JOB NO. 3521

13 St. John Street, Manchester

For Nilesh Bhatt

Additional information requested by planning:

Living Wall details

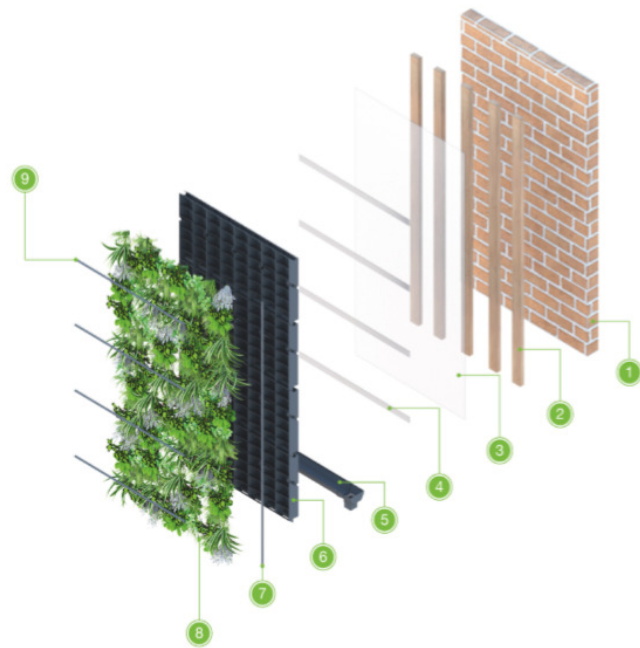
8) Please provide details of the proposed living wall, including specification, details of who would install it and relevant experience, and proposed maintenance strategy.

Shown below is a sample of a maintenance schedule for the United Kingdom. There must be a degree of flexibility allowed for in each maintenance package as some seasons require more labour than others.

Having successfully designed, grown and installed the ANS Living Wall System™, maintenance is essential to guarantee the wall has a fresh and vibrant appearance on an ongoing basis. ANS offer a professional maintenance contract to maintain the living wall on site. This ensures that the Living Wall grows suitably, is pruned accurately and is fed as appropriate.

- Visually inspect the wall
 - Check the moisture levels in wall and adjust irrigation as necessary
 - Check the well-being of plants
 - Carry out remedial work to wall as found to be necessary
 - Remove weeds
 - Prune in accordance with seasonal requirements
 - Dead head as necessary
- Treat for pest and disease
 - Apply feed and nutrient as necessary
 - Check and service irrigation plant and ensure correct operation
 - Sweep and tidy below wall
 - Check run off outlets for blockage
 - Replant at any plants that have failed due to poor workmanship
